ADDENDUM NO. 1

- A. Date: 27 June 2012
- B. From: Bahr, Vermeer and Haecker Architects, Ltd.
- C. To: Prospective Bidders.
- D. Project: Lexington Public Schools
Bryan Elementary School Addition & Renovation
Bid Packages No. 7 – No. 32
Lexington, Nebraska
- E. This addendum is issued by the Architect to all bidders of record prior to receipt of proposals. Bidders shall acknowledge receipt of this addendum by so indicating on the Bid Form. Failure to do so may subject Bidder to disqualification.
- F. All information and instructions given herein shall become a part of the Contract Documents.
- G. This Addendum contains seven (7) total pages with one (1) attachment.

TYPICAL SINGLE LOAD OCCUPANCY DETECTOR DETAIL

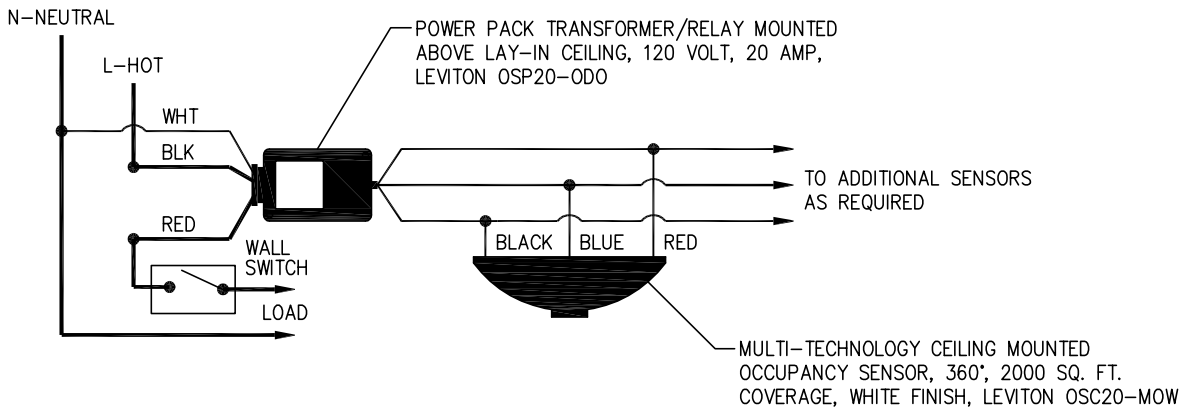
- A. Occupancy Sensors
 - 1. After installation, the contractor shall adjust each sensor’s direction, sensitivity and timing.
 - 2. See Attachment “1E” for the Occupancy Sensor Detail.
- B. General Item
 - 1. Refer to Section 08 7100 – DOOR HARDWARE for electrical work required for door hardware installation.
 - 2. For clarification the Contractor and the Contractor’s Subcontractors are responsible for cleaning up their work area each day.
